# Advisory Plan Commission

## Town of Brownsburg

**Request Type:** Development Plan Review

<b>CASE NUMBER</b>	PSDP-23-21
<b>APPLICANT</b>	Brian Moench, Moench Engineering
<b>LOCATION</b>	4005 N CR 1000 E, 32-08-17-365-002.000-016
<b>PARCEL SIZE</b>	2.96 acres

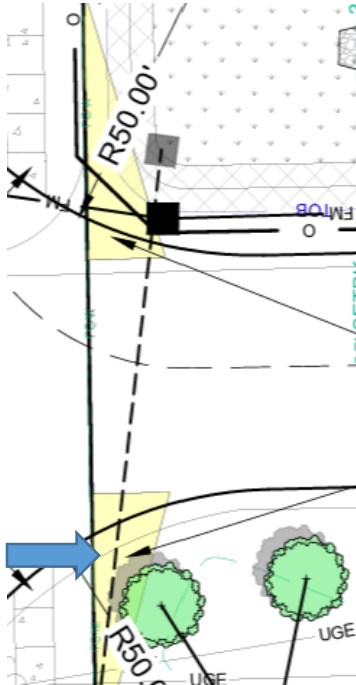
- a) The project meets the minimum front setback of 35', the minimum side setback of 20', and the minimum rear setback of 20'. Maximum lot coverage is 80% in an MS district, this project is only 65.4%. The maintenance building on the site is 30'-9" tall, which is under the maximum height allowed for a primary structure (65'). However, to date no elevations of the office building have been submitted, to review for compliance.

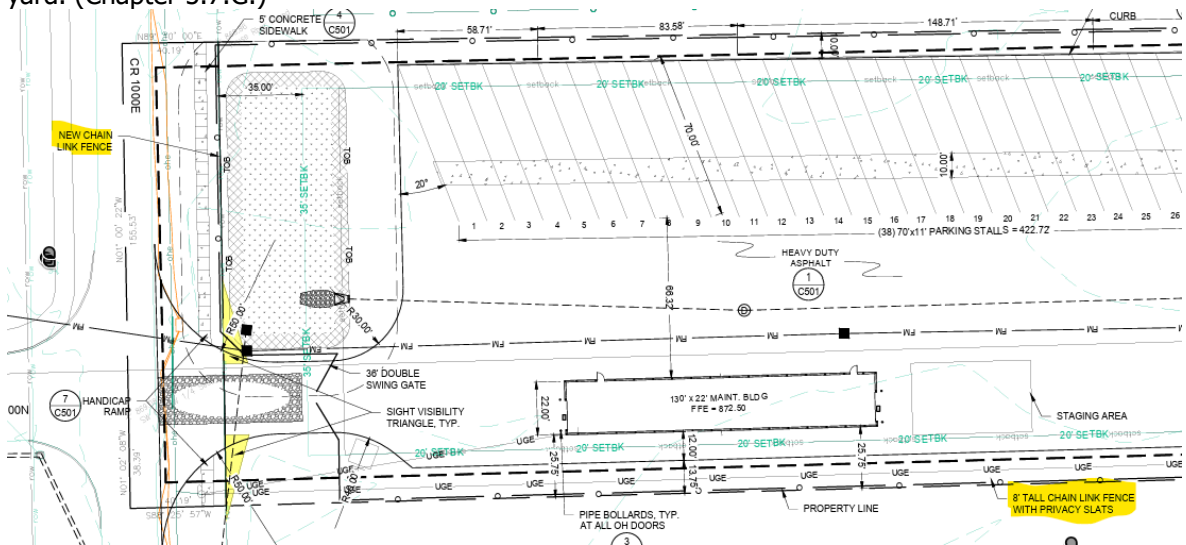
- d) *Vision Clearance Triangle*: The VCT's are labeled on their Civil and Landscape Plan submittal. There is a red/ sugar maple (canopy, deciduous tree) that has a listed height on the planting schedule of 40-50 ft and a spread of 30-40 ft that is in violation of Chapter 5.16.B. Vertical Area on page 142 of the UDO. 'Landscaping shall be permitted to be placed or to project into the vision clearance triangle between the heights of two feet and nine feet above the crown of the adjacent roadway.' The proposed tree would exceed this requirement and therefore need to be moved back to the east out of the VCT. The proposed fence on the north side of the access drive (shown below) is within the applicant's vision clearance triangle.

Since the continuance on December 17<sup>th</sup>, 2025, the applicant has resubmitted the landscape plans. This led to a deletion of the vision clearance triangles from the new landscape plan shown below). The triangles will need added to the new landscape plan.
